Model: Gim-P1a		Date: 23-Feb-15	No.: RM171002
Subject: Service manual revision		Prepared by: T.Suzuki	
From: 3rd Tech. Support Sec. Service Support Dept.,			
Classification:	<input type="checkbox"/> Troubleshooting	<input type="checkbox"/> Part information	<input type="checkbox"/> Action required
	<input type="checkbox"/> Mechanical	<input type="checkbox"/> Electrical	<input checked="" type="checkbox"/> Service manual revision
	<input type="checkbox"/> Paper path	<input type="checkbox"/> Transmit/receive	<input type="checkbox"/> Retrofit information
	<input type="checkbox"/> Product Safety	<input type="checkbox"/> Other ()	<input type="checkbox"/> Tier 2

Subject: Dirty reverse side of printing sheets		Prepared by: J.Kitagawa	
From: 1st Tech Service Sect., MFP/P Tech Service Dept.			
Classification:	<input type="checkbox"/> Troubleshooting <input type="checkbox"/> Mechanical <input type="checkbox"/> Paper path <input type="checkbox"/> Product Safety	<input checked="" type="checkbox"/> Part information <input type="checkbox"/> Electrical <input type="checkbox"/> Transmit/receive <input type="checkbox"/> Other ()	<input type="checkbox"/> Action required <input type="checkbox"/> Servi

Inside of the right cover:

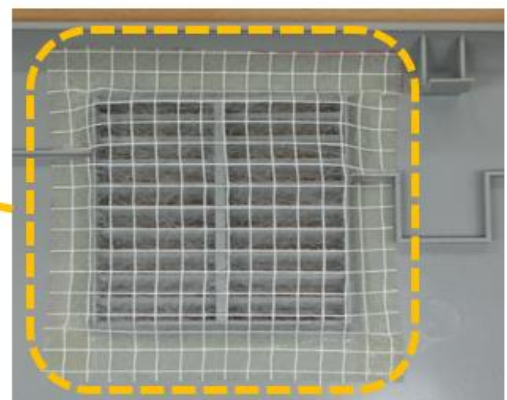
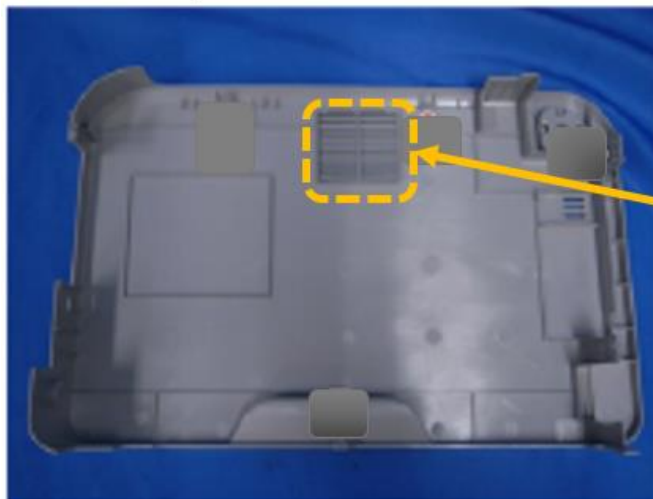
A filter sheet is added to prevent the entry of abnormal substances coming from intake fan.

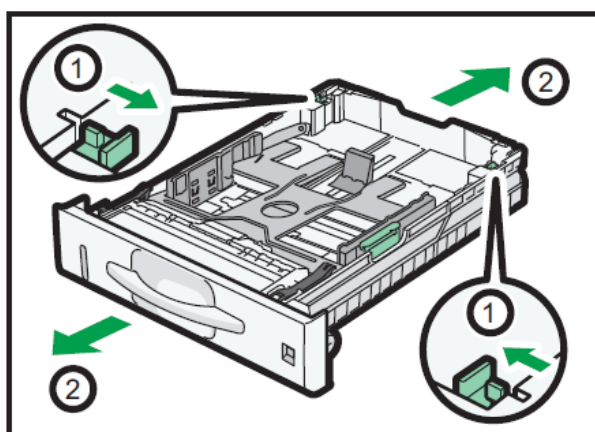
- A) The end fence may be kicked a few notches back by the loaded paper if the fence is adjusted after the paper is loaded.
- B) The end fence may be pushed back when the paper is loaded if the catches (1) do not lock the tray extension.

Tray shown flipped back:

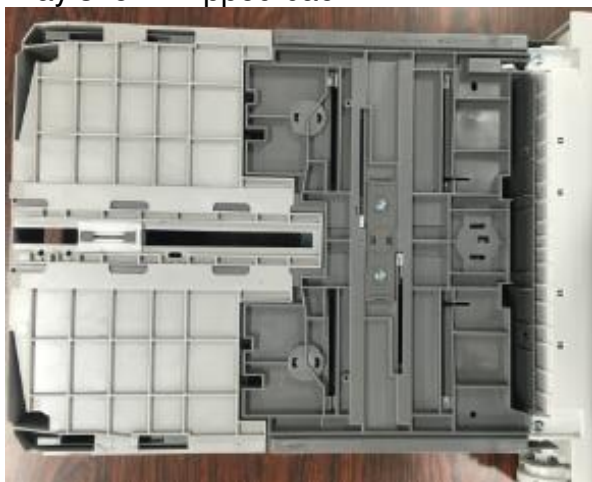
Options for fixing the end fence in place:

Advise the user to fix the position of the end fence **before** loading the paper (as mentioned in the Operator's Instructions). If the user uses only A4SEF, Letter SEF, or A5 SEF, then the end fence can be fixed in place using the following screw:

5. Manual Feed Section 2

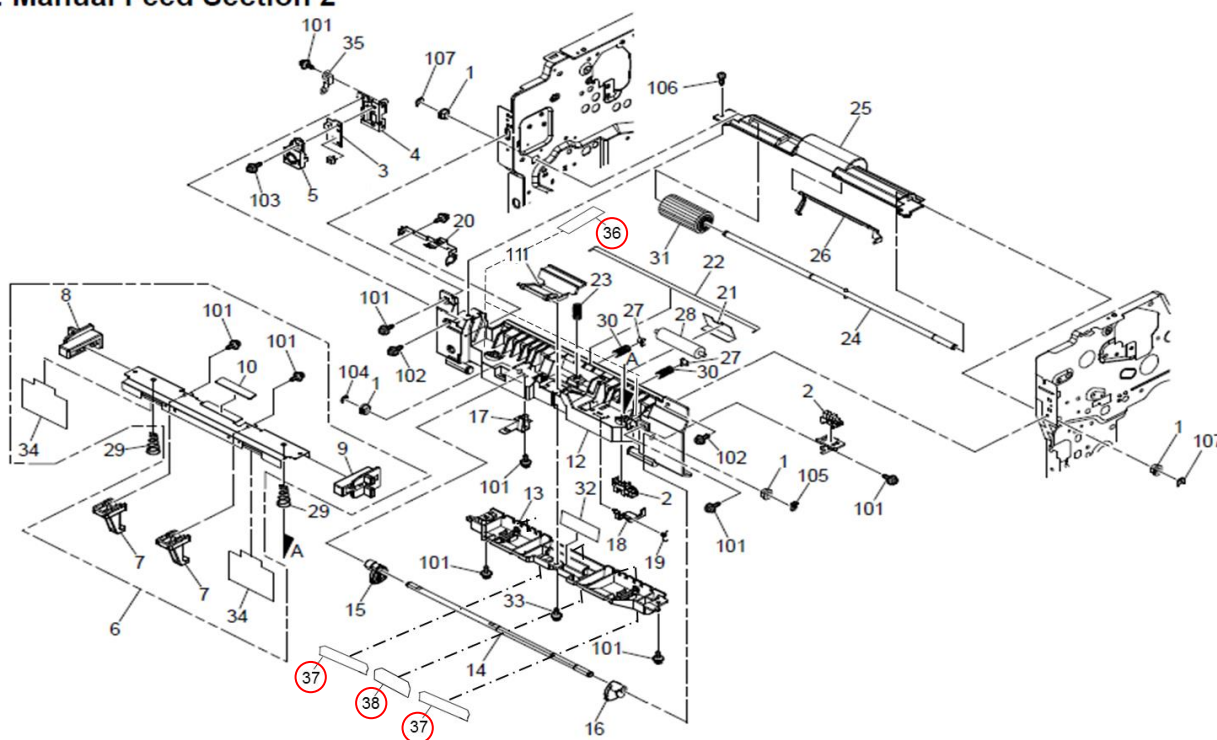
Change: The following parts were registered as service parts.

Reason: To meet requests received from the field.
